SDNP/22/03543/DCOND: Land at Greenway Lane, Buriton: Discharge of Conditions 3 (Materials), Condition 11 (Hard Landscaping), Condition 12 (Planting Proposals), Condition 14 (External Lighting), Condition 16 (EV Charging Spaces) and Condition 21 (Air Source Heat Pump Noise) of planning approval SDNP/21/02014/FUL.

BURITON PARISH COUNCIL

Figure 6

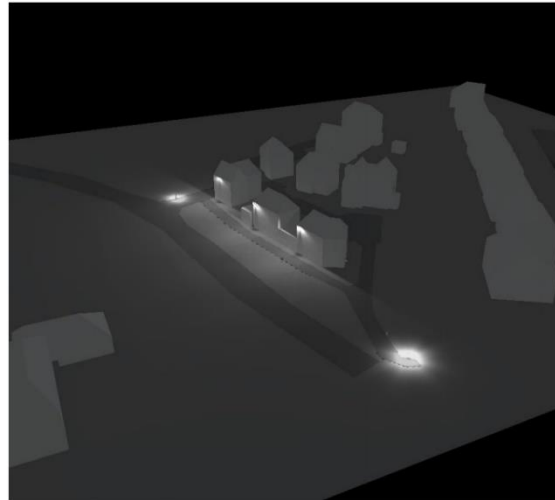
- d) The revised proposals now submitted to SDNPA appear to include 26 external lights – none of which assist along the new footpath. This is a completely different lighting scheme and must not be approved. The original scheme had been drawn up as part of a thorough study with lighting specialists and was approved by the SDNPA Planning Committee only because there was due to be “minimal external lighting, which is on the road frontage boundary.”

- i) Condition 13 (relating to ecology) makes this explicitly clear, stating that “Development shall proceed in accordance with ... figure 6 of the lighting assessment by Mapledean Projects (April 2021)”. This should not be changed.

- j) Figure 6 from the lighting assessment (and its visual representation: figure 7) are reproduced overleaf.

- h) All the good work undertaken by the SDNPA and by Mapledean Projects and their lighting experts would be ignored if this revised scheme was accepted. The original proposals, as approved, must be retained.
